Response to the requests for review of project activity
"Mokpo Landfill Gas Recovery project for Electricity Generation"(2834)

27 November 2009

EMC

Figure 1. Linear regression analysis using a unit cost of electricity purchase

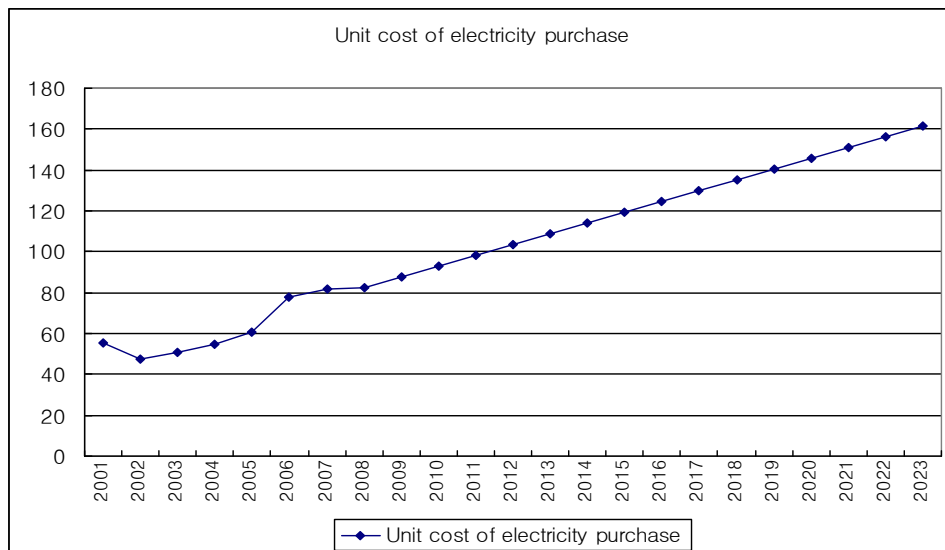
- EMC conclude that it is reasonable for setting a same unit price of electricity sales through whole project lifetime because of high uncertainty of future assumption. EMC carried out linear regression analysis using a publically opened data from 2001 to 2007⁹⁾ to estimate the possibility of increasing. Average unit price of electricity sales is 122 won/Kwh during project lifetime, and IRR is –1.37% which is much smaller figure than benchmark ratio(5.24%). Unit price of electricity sales should be over 140.3won/Kwh to be economically attractive and IRR will cross the benchmark ratio.

- There are low possibilities of decreasing for total investment cost, O&M cost, So there are no synergistic effects to increasing unit price of electricity sales. Because above reason, EMC concluded that sensitivity analysis performed appropriately.
